South Dublin County Council  
Planning Department  
County Hall, Tallaght,  
Dublin 24.

19<sup>th</sup> October 2021  
Our Ref: 1660

**RE: Additional Information response relating to Planning Application Reg. Ref. SD2/21A/0182.  
Applicant: Airtraks Ltd. T/A ATC Computer Transport.**

Illumination intensity as provided by Axiseng Consulting Engineers.

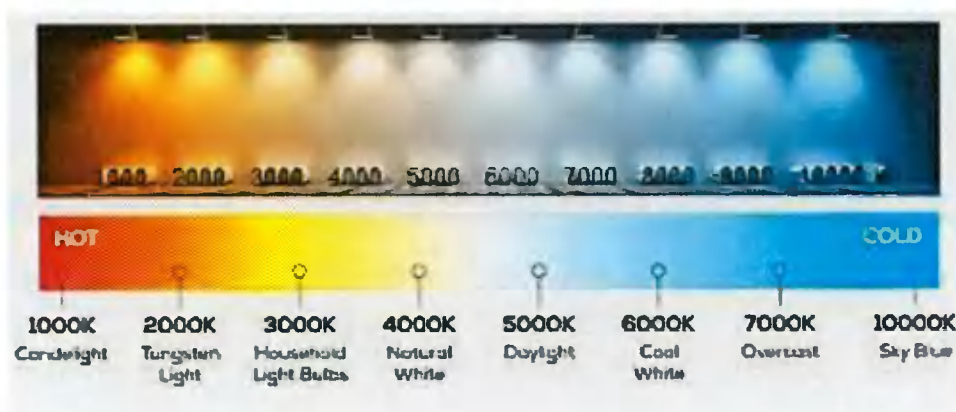
1. The appearance of the building frontages have been assessed as per the local Authority's request. Both the proposed entrance porch addition and the visible front of the separate workshop building have received some glazing panels.  
The addition of these glazing panels will function to break up what would otherwise be metal cladding predominant elevations. Updated elevations drawings Ref. D1660-GA-A-06 and D1660-GA-A-05 are enclosed for the Local Authority's consideration.
2. The inclusion of internally lit signage has been considered and while the Client wishes that the signage remains as proposed in appearance, it will not be internally illuminated. The external building signage is now proposed to be externally illuminated at night.

The Mechanical & Electrical Consultant Engineer appointed to this project has assessed the level of external illumination and their recommendations are included in Appendix A.

"The external illuminated signs will not present any potential impact on the local bats provided that dark corridors (north-east & south-west borders) are not infringed upon by the sign lighting with the lighting specifications (lux levels) in line with those outlined in the Bat Report for the site (i.e.) 2700k to 3000k".

2 No. fittings for each sign.

Mounted on brackets approximately 1m from the sign, this would produce an average illuminance across the sign of **98.5Lux**.

With an installed power density of **52.4W** or **2442 lumens** per sign.

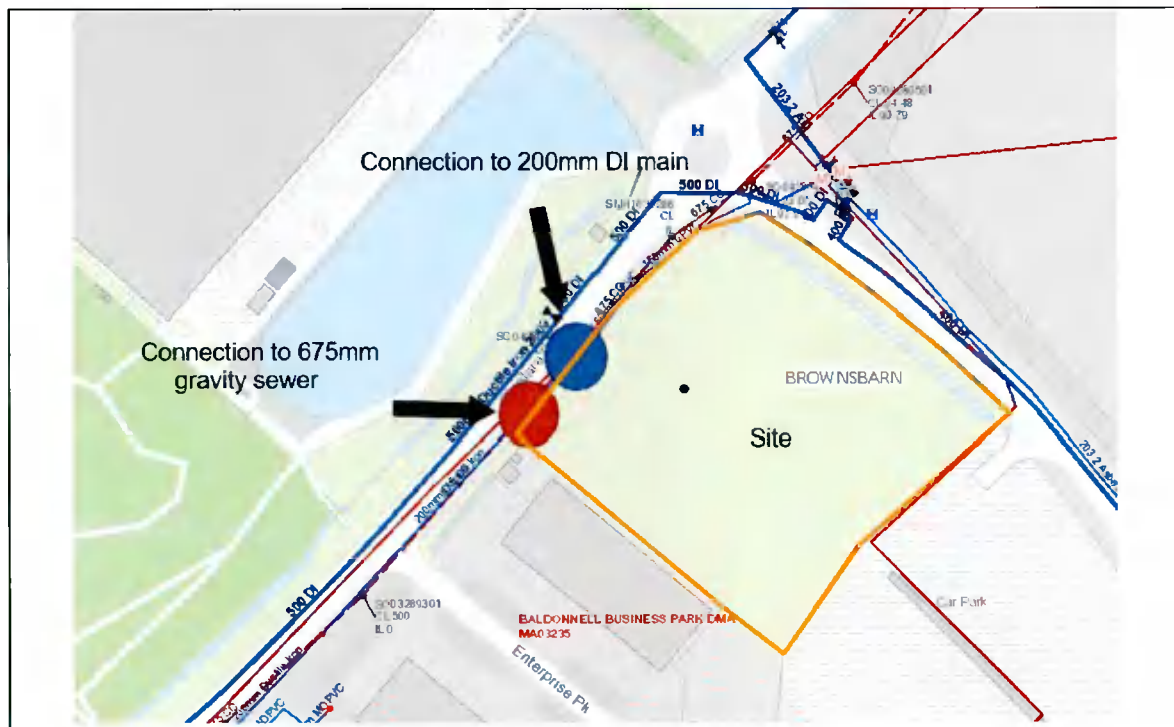
4. (a)&(b)  
We have applied to Irish Water for Pre - Connection Enquiry relating to connection of the subject development to the public water and wastewater infrastructure. The Confirmation of Feasibility response letter is enclosed in Appendix B which states that connections to adjacent services can be accommodated without infrastructure upgrades.

It is the responsibility of the applicant to verify that a gravity connection to the adjacent Irish Water sewer is feasible.

The map included below outlines the current Irish Water infrastructure adjacent to your site:
